STAFF RECOMMENDATION
116 Mockingbird Road
April 18, 2012

Application: New construction – Accessory structure
District: Cherokee Park Neighborhood Conservation Zoning Overlay
Council District: 24
Map and Parcel Number: 10312023900
Applicant: Douglas Linfert, Owner
Project Lead: Sean Alexander, sean.alexander@nashville.gov

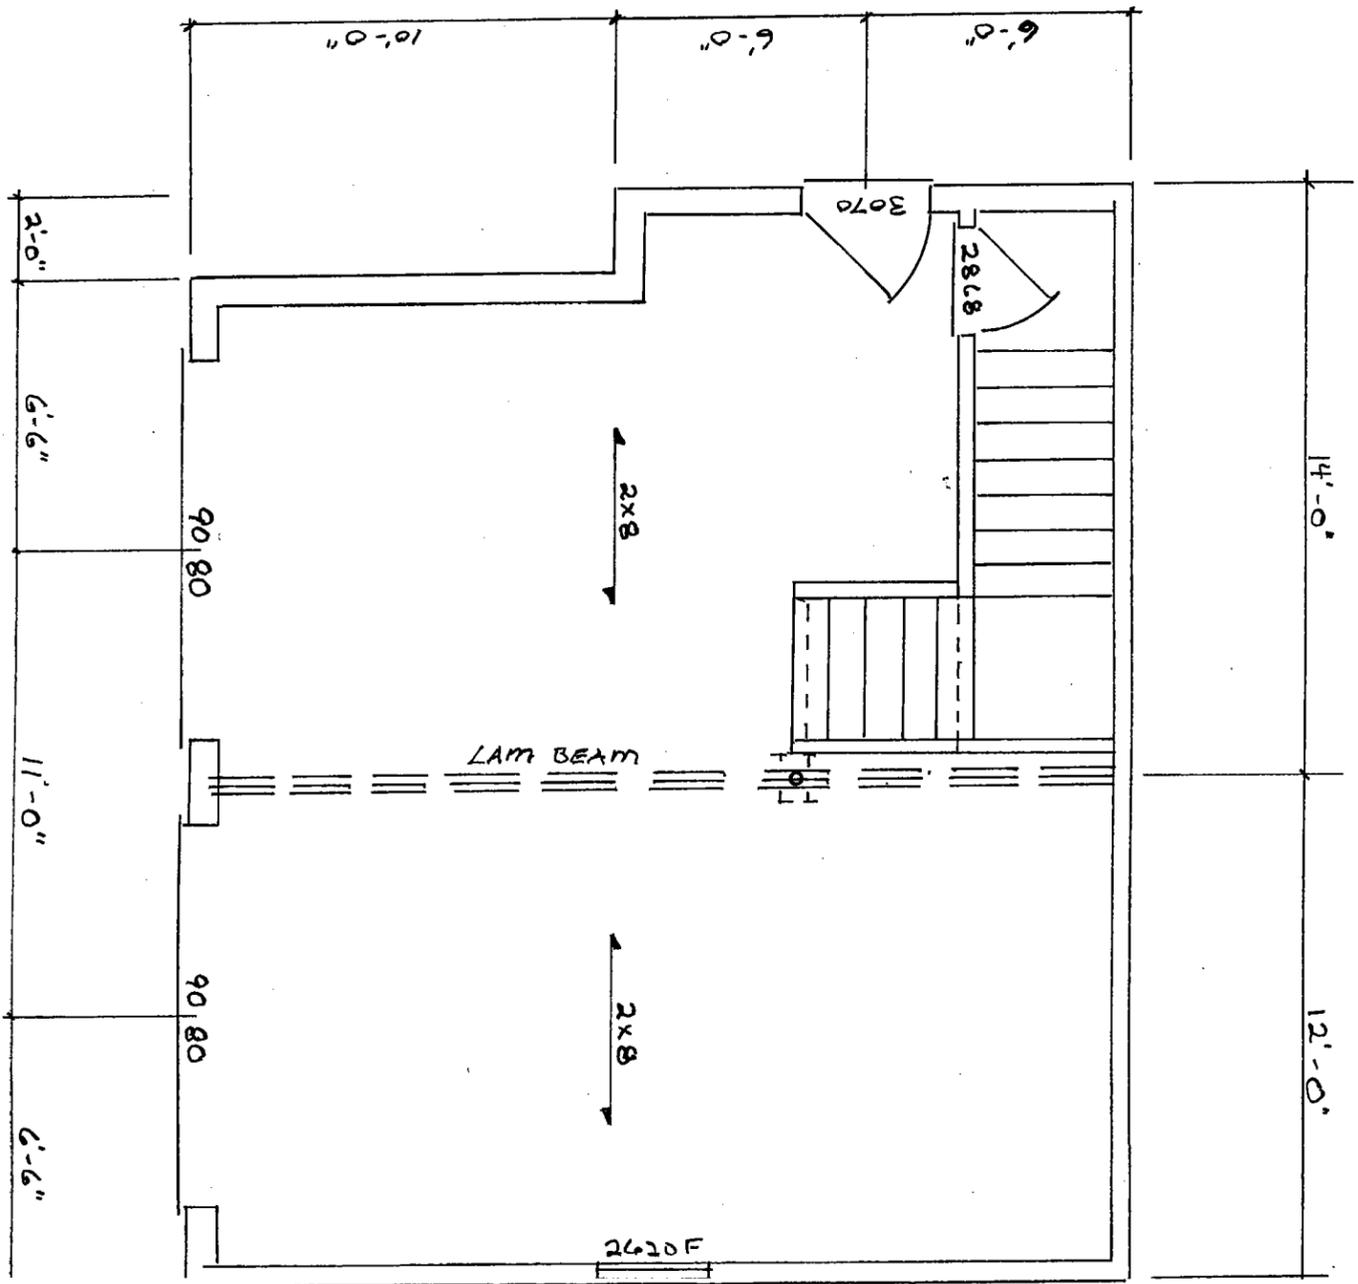
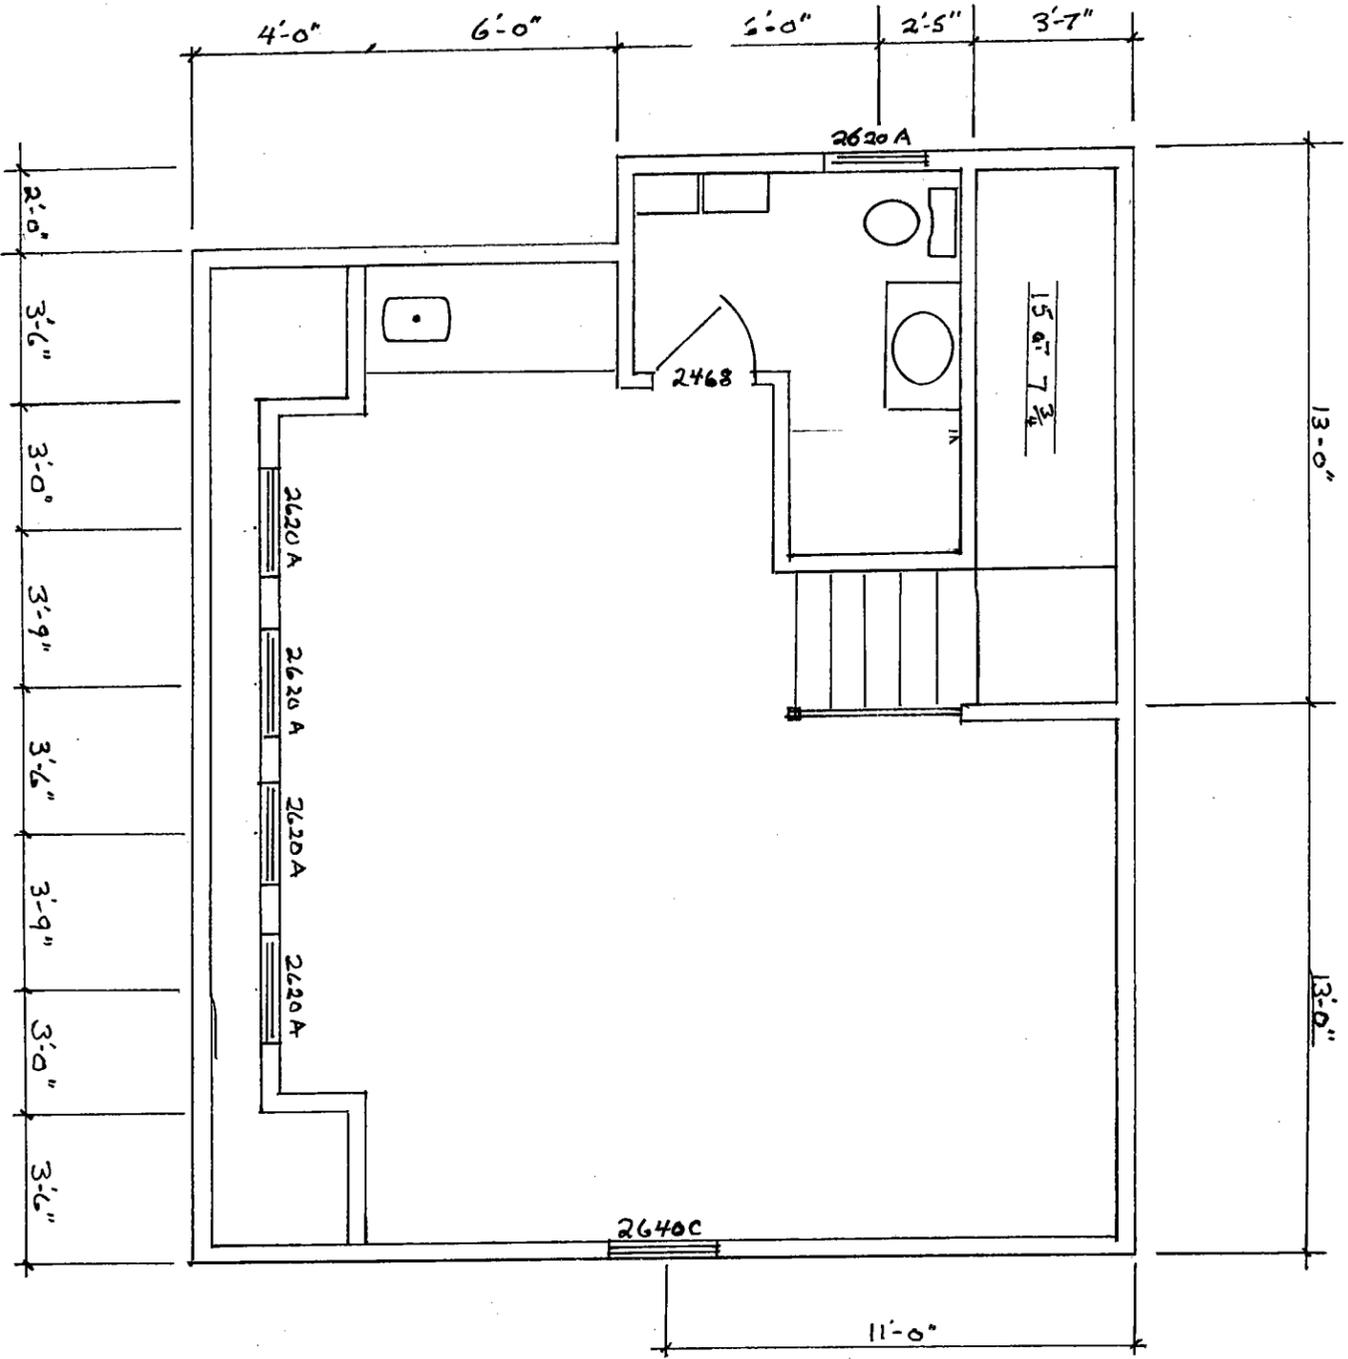
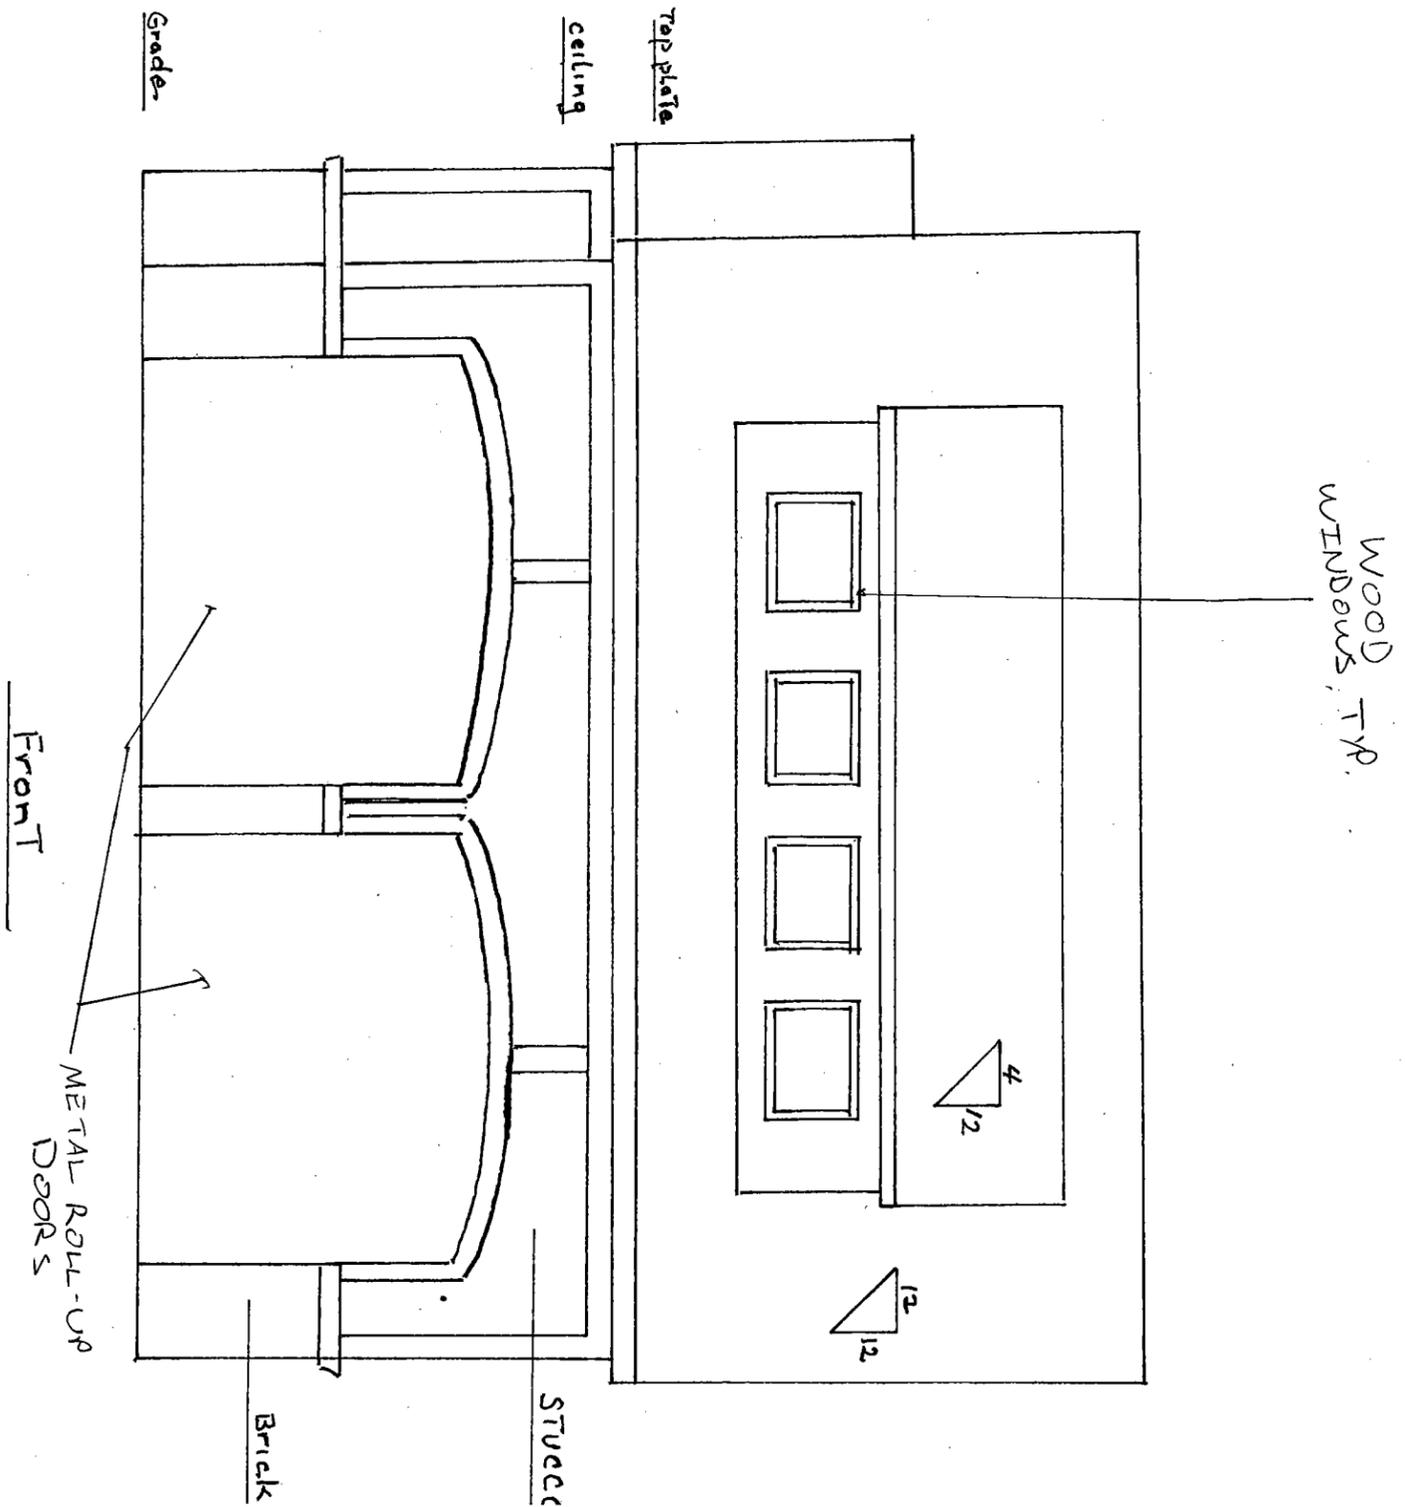
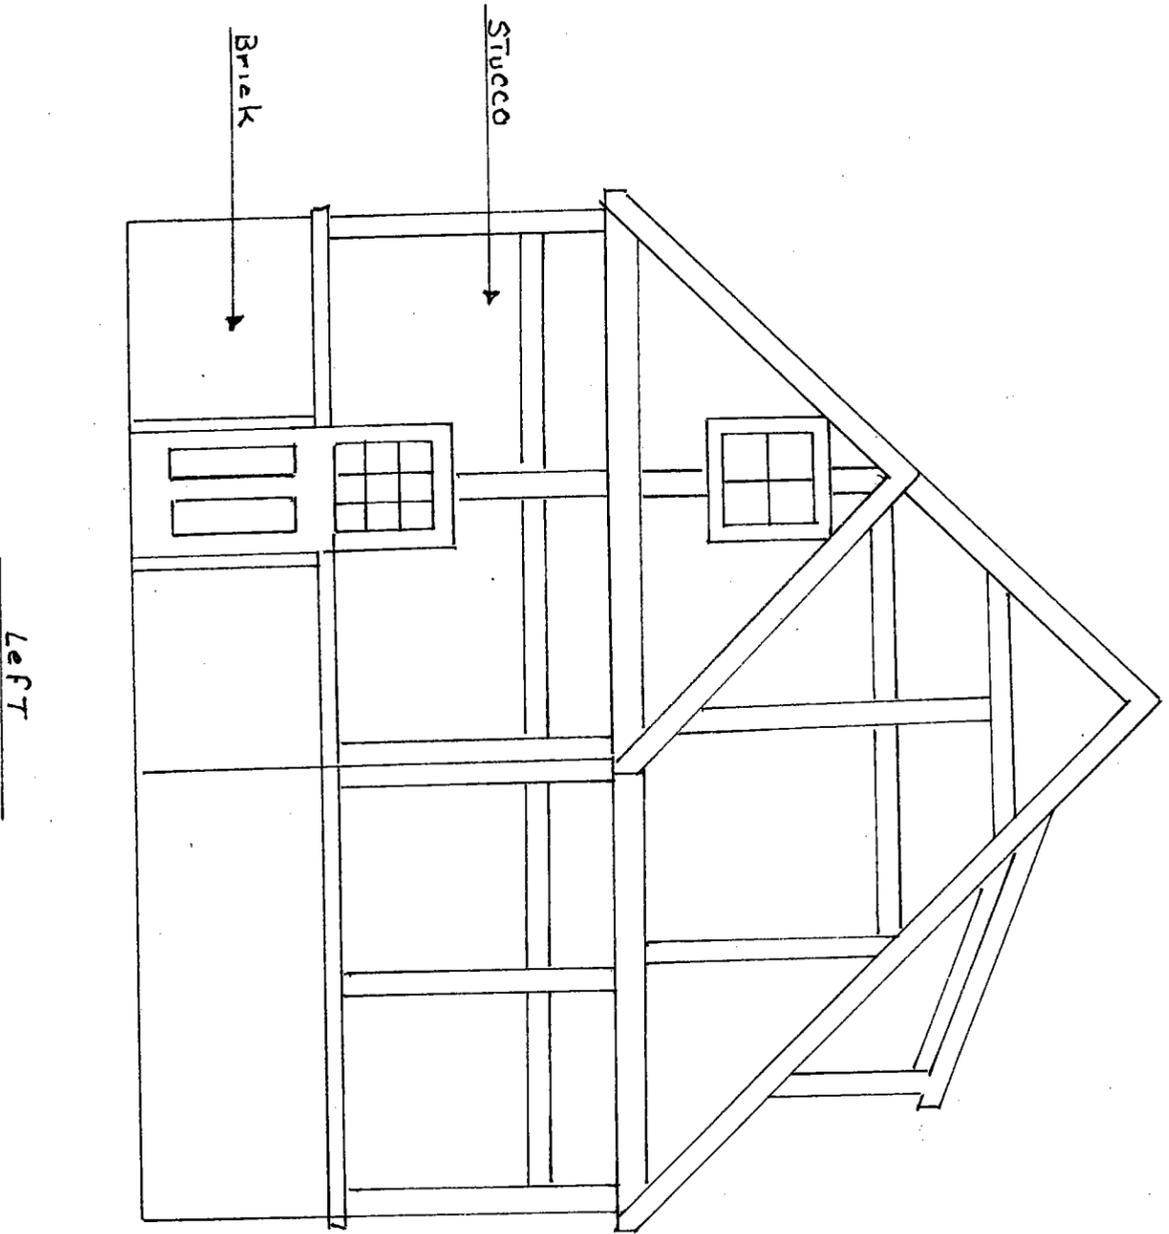
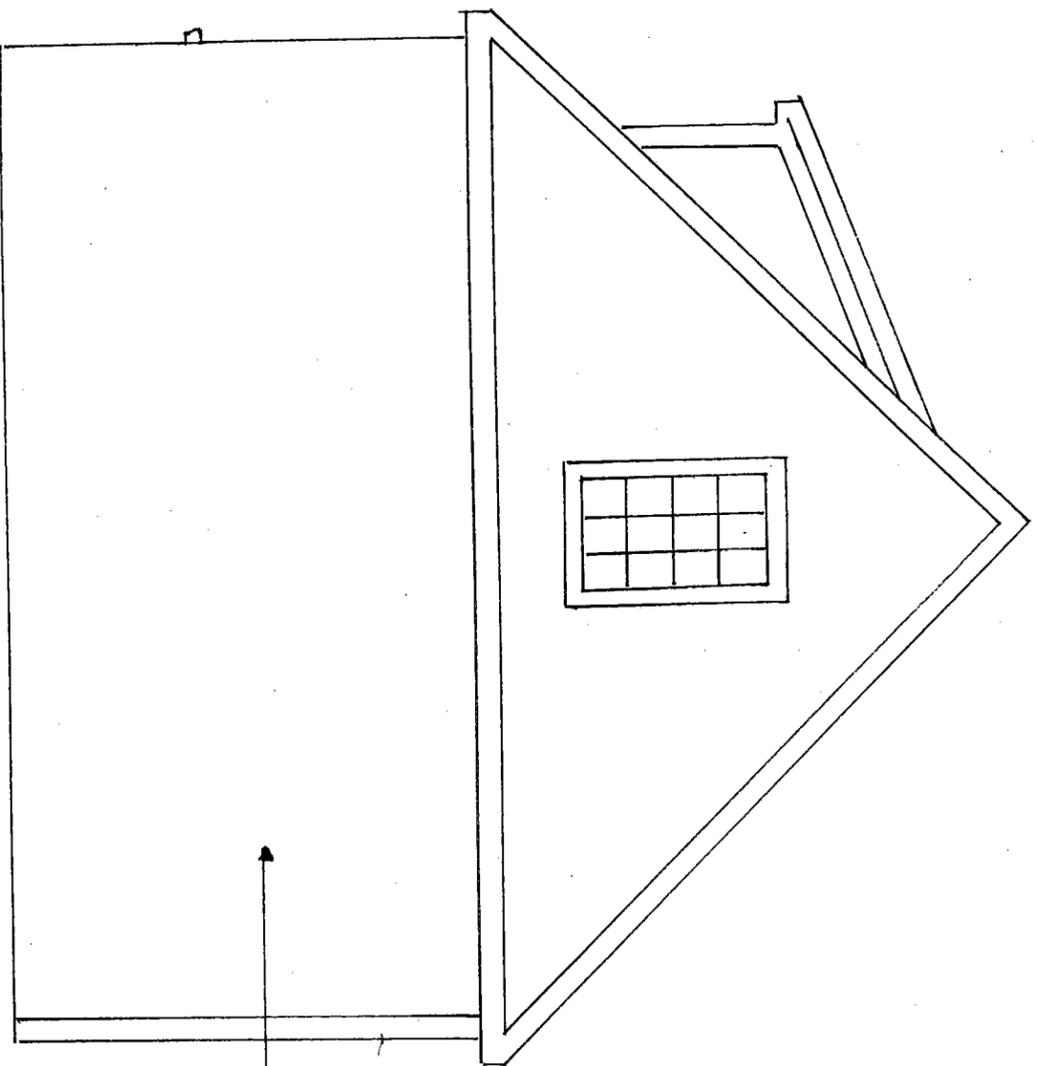
The roof of the structure will be twenty-two (22') feet above grade, with an eave line at ten feet (10') above the floor level. These proportions match the roof and eave heights of the house, but the perceived massing of the garage will be reduced because the grade drops three to four feet (3' to 4') from the house to the back of the lot. The scale and height of the structure are compatible with surrounding accessory structures and meet guidelines II.B.1.a and II.B.1.b.

The walls of the structure will have decorative half-timbering with stucco to match the materials of the existing structure. The rear walls of the structure may have cement-fiber clapboard siding, which would also be compatible. The foundation will be concrete (slab), and the roof will be fiberglass-asphalt shingles to match the house. The vehicle doors and front-facing pedestrian door will be metal, and will reflect to character of the house. There will be wooden windows in the dormer and above the pedestrian door. These materials meet guideline II.B.1.d.

The roof of the garage will be a front-oriented gable with a 12:12 pitch, matching the pitch of the primary structure. This will be compatible with surrounding historic structures and will meet guideline II.B.1.e. There will be a shed-roofed dormer facing the interior of the lot, obscured from the right of way by the house.

The submitted floorplans show a full bathroom in the upperstory of the structure, which would only be permitted if a Detached Accessory Dwelling Unit Covenant were filed. The applicant has informed Staff that they intend to eliminate the shower fixture in order to meet Zoning requirements for non-dwelling accessory structures,

Staff recommends approval of the application to demolish the existing carport and construct a new two-car garage, finding the scale, location, and materials of the new structure to be compatible with surrounding structures and to meet the Cherokee Park Neighborhood Conservation Zoning Overlay design guidelines.
